QUESTION 005.1

The statement in Section 5.2.1.1 of the FSAR with regard to your compliance with 10 CFR Part 50, Section 50.55a, Codes and Standards Rule, is incorrect as a number of Quality Group A components within the reactor coolant pressure boundary are not in conformance with the applicable ASME Boiler and Pressure Vessel code and addenda as required by the rule.

FSAR REV.65

FIGURE 021.72-1, Rev 47

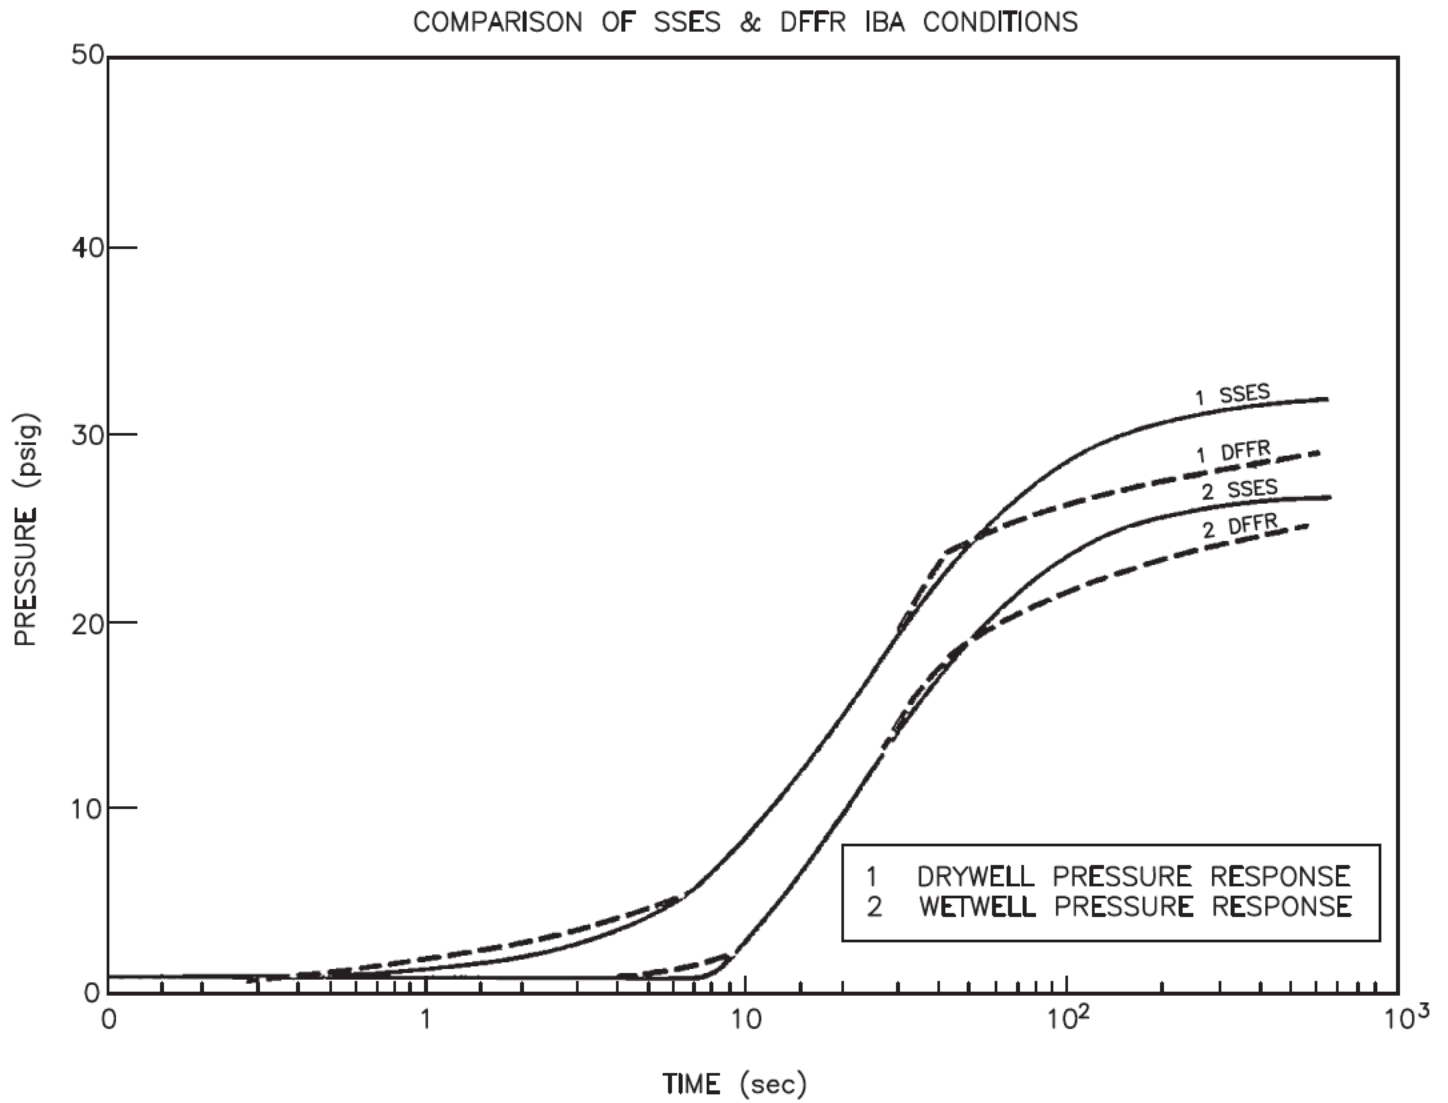
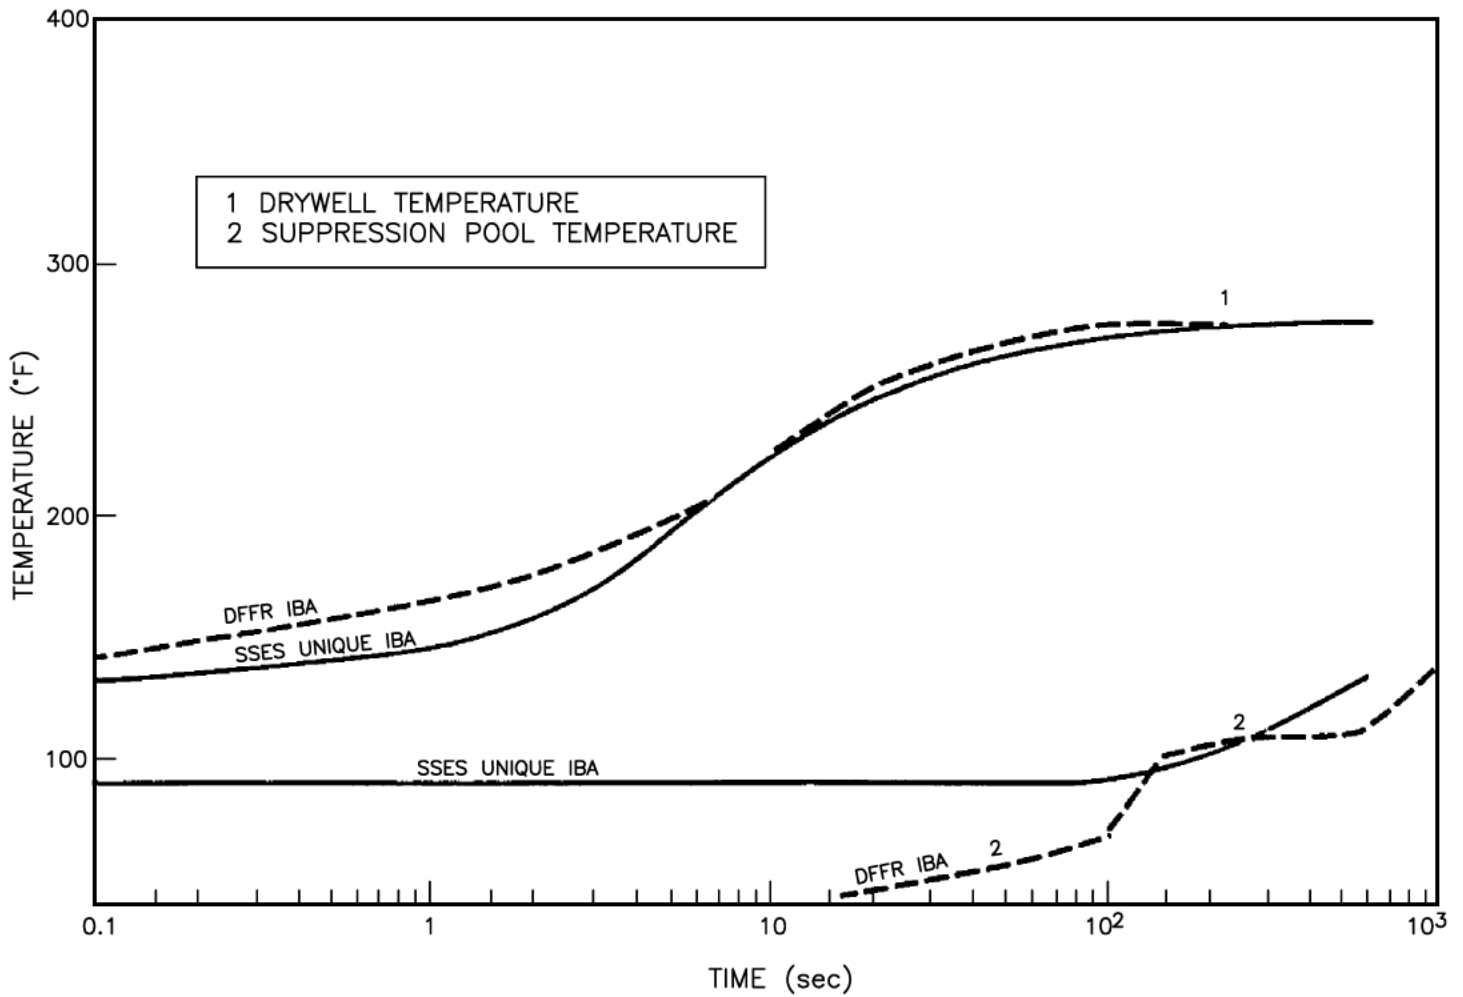
RESPONSE:

The Susquehanna SES FSAR Subsections 6.2.1.1.3.3.4 and 6.2.1.1.3.3.5 give consideration to the SBA and IBA conditions and FSAR figures 6.2-14 and 6.2-15 give the IBA unique curves for Susquehanna SES based on the initial conditions as given in FSAR Tables 6.2-1 thru 6.2-4. In comparing the IBA Susquehanna SES unique FSAR figures with the Susquehanna SES DAR figures 4-50, 4-51 and 4-52, which are generic DFFR, SBA and IBA, it can be seen that basically the generated curves provide similar design basis mass energy data. (See figures 021.72-1 and 021.72-2) Thus we expect the Susquehanna SES SBA conditions to be similar also to the DFFR (or DAR) figures. The parameters for the DFFR and Susquehanna SES are provided in DFFR (NEDO 21061) Table 4-1 and Susquehanna SES FSAR Tables 6.2-1 and 6.2-4 respectively. The differences in parameters are as follows:

<u>DFFR</u>	<u>SSES</u>
Drywell Free Air Volume ft ³	2.029 X 10 ⁵	2.396 X 10 ⁵
Wetwell Free Air Volume ft ³	1.455 X 10 ⁵	1.4859 X 10 ⁵
Wetwell Water Volume ft ³	1.2 X 10 ⁵	1.224 X 10 ⁵
Drywell Initial Pressure psig.	0.75	1.5
Wetwell Initial Pressure psig.	0.75	1.5
Vent Submergence ft.	11	11.5
Number of vents	108	87

FIGURE 032.57-1, Rev 47

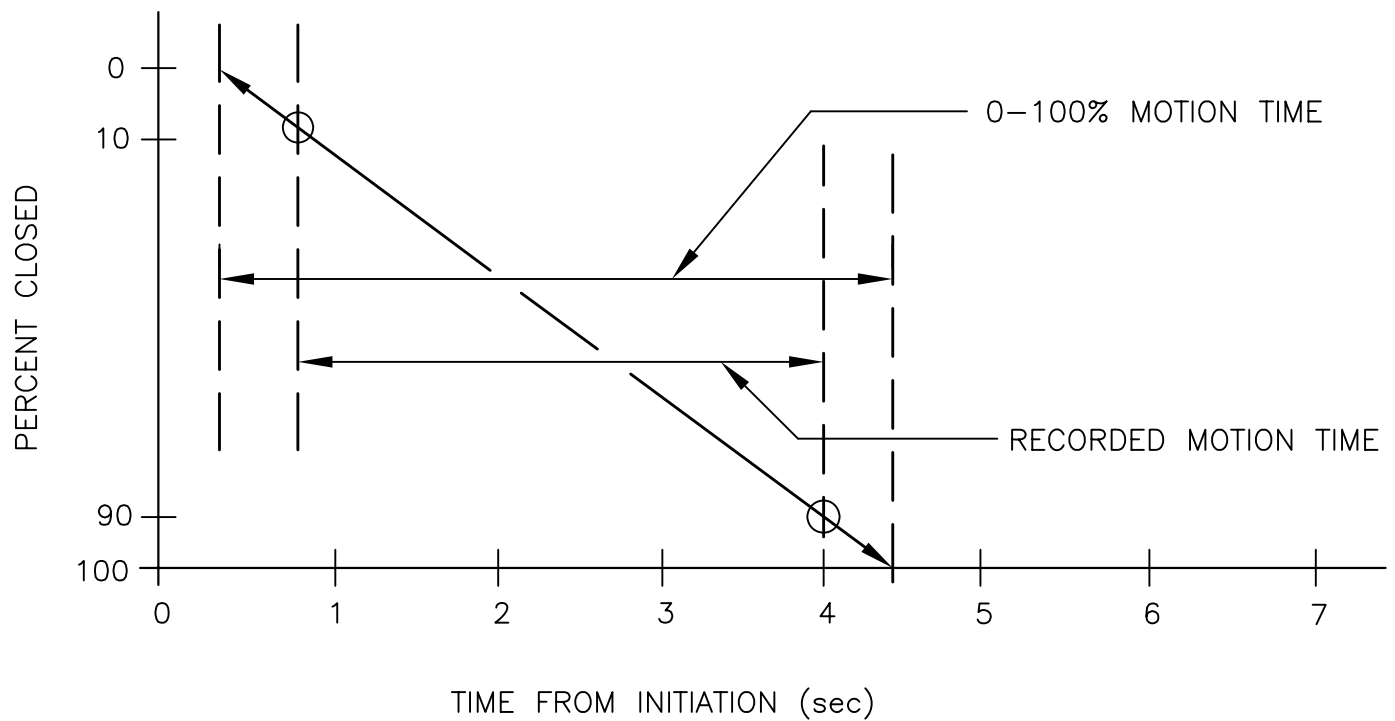
QUESTION 032.57

Describe test method to be used to verify closing times for main steamline isolation valves are within limits of technical specifications. Identify any special design features to facilitate this test. Table 6.2-12 is referenced for closure times of main steamline isolation valves, but time has been omitted from that table. What is the range of acceptable closure times?

The determination of the MSIV closure was an extrapolation from the position lights as illustrated by Figure 032.27. The closure time is the summation of the time between the initiation signal and the 90% closed light plus $1/9$ times the time interval between the initiation and the 90% closed lights.
